**HILLVIEW, VALE OF HEALTH, HAMPSTEAD, NW3 1AN
LONDON BOROUGH OF CAMDEN**

PLANNING, DESIGN + ACCESS STATEMENT
REFURBISHMENT OF PROPERTY TO A SINGLE DWELLING

September 2016
O/R: 649-16

2016/3969/PRE - Pre-Application Stage with Camden Council

COMPARATIVE REAR ELEVATIONS (PRE-APP-LEFT, APPLICATION-RIGHT)

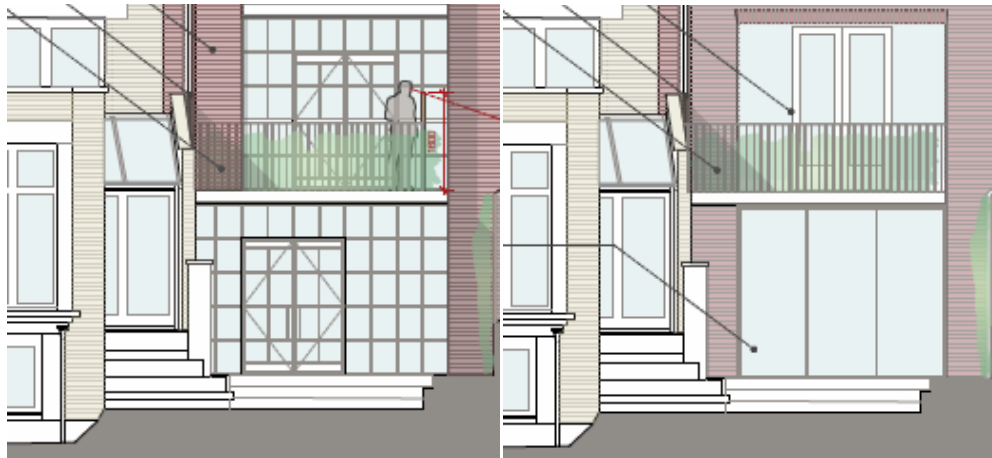
- 4.10 Given that it would maintain a subordinate relationship with the host dwelling it is considered acceptable in principle. Currently it is necessary to walk down a few stairs to access the conservatory; the proposal also seeks to address internal level changes by raising the floor level of the new extension to meet the rest of the house resulting in a higher extension than at present. This is considered to be OK given that the height of the lower ground floor of the neighbour to the south is considerably higher.
- 4.11 **Response:** This is welcomed
- 4.12 In terms of detailed design, the rear and side elevations of the new extension would be fully glazed with Crittal style windows. While the high volume of glass is similar to the current

conservatory I would advise that a combination of brick and glazing is used to prevent it from appearing too stark and incongruous compared to the host dwelling.

4.13 **Response:** The revised scheme has used implemented a combination of brick and glazing, as advised. Please see comparative rear elevations below:

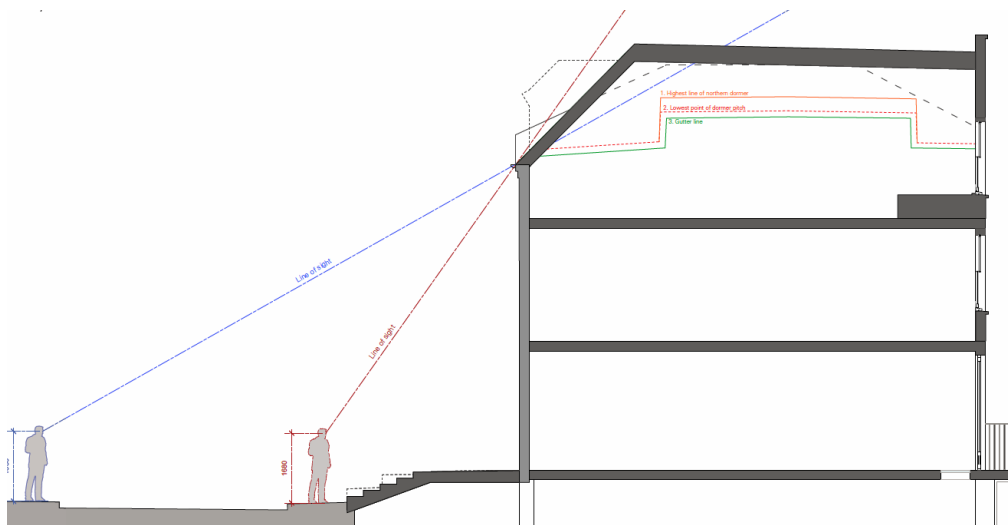
4.14 Terraces or balconies are an established feature of the surrounding properties and the proposed terrace would not be out of character. It would occupy only part of the flat roof below and therefore be of an acceptable residential scale. It would be preferable to not have the privacy screening which is likely to appear bulky, please refer to the Amenity section below for further detail. It is recommended that the balustrade is black metal railings, the preferred choice for a conservation area.

4.15 **Response:** This view is welcomed. Black metal railings are now proposed with privacy screening removed from the edges of the terrace.

PROPOSED REAR ELEVATION WITH TRADITIONAL MATERIALS AND PROPORTIONS

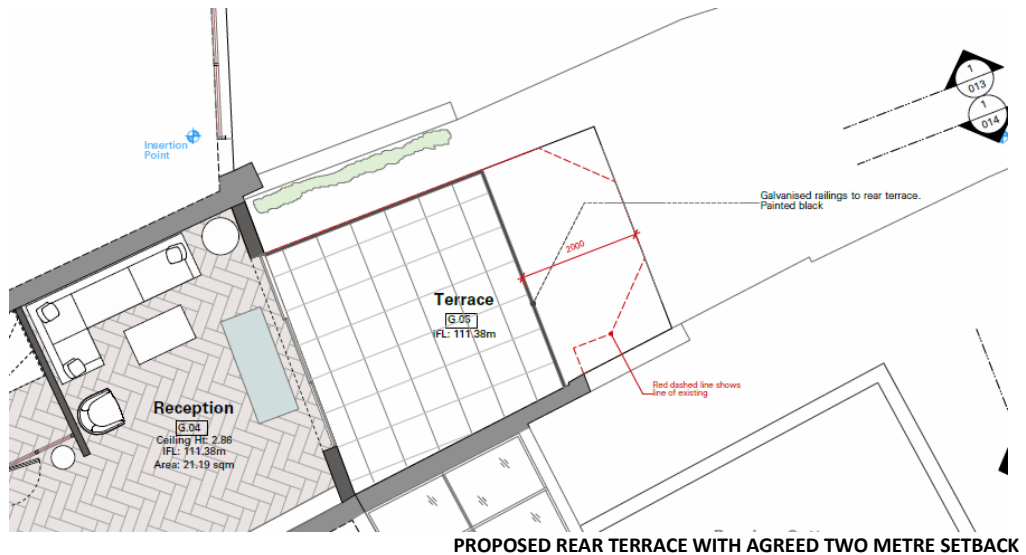
4.18 It is proposed to install a high volume of Crittal glazing across the rear elevation which would replace the brickwork down the central section of the property...

4.19 This is therefore considered an unacceptable alteration for a period property of this nature, a positive contributor in the Hampstead Conservation Area, contrary to Policy DP25 which states that the Council will only permit development within conservation areas that preserves and enhances the character and appearance of the area. It is therefore recommended that the original window openings are retained.

4.21 It was also asked whether the windows could project from the rear elevation like bay windows thereby allowing more light in. Again, this would not be supported at high level due to the impact it would have on the uniformity of the glazing along a terrace of positive contributors, however it would be acceptable at ground floor level where it would not be visible from anywhere.

4.20 **Response:** A more traditional approach has now been taken with the rear elevation at ground floor and above. Traditional materials and proportions are now proposed, in a style that will complement the rest of the terrace.

4.22 **Response:** The small projections at the upper levels to the rear have now been removed, as advised.

GROUND FLOOR REAR TERRACE

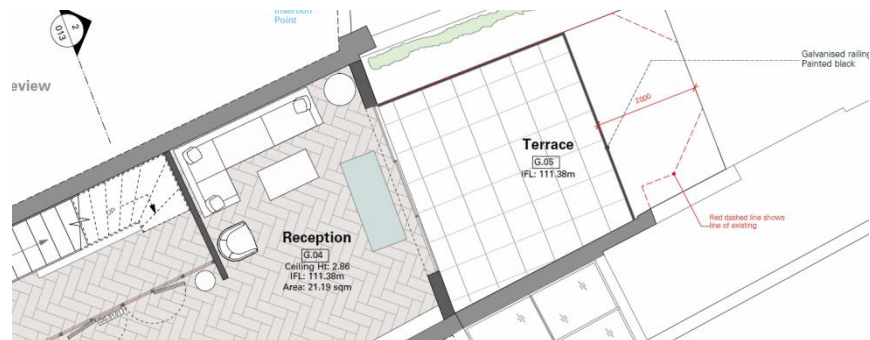
7.54 At pre-application stage, the case officer did acknowledge that the context to the rear did involve a level of overlooking between properties. As advised at pre-application stage, the size of the rear terrace has been reduced with privacy screening used sparingly.
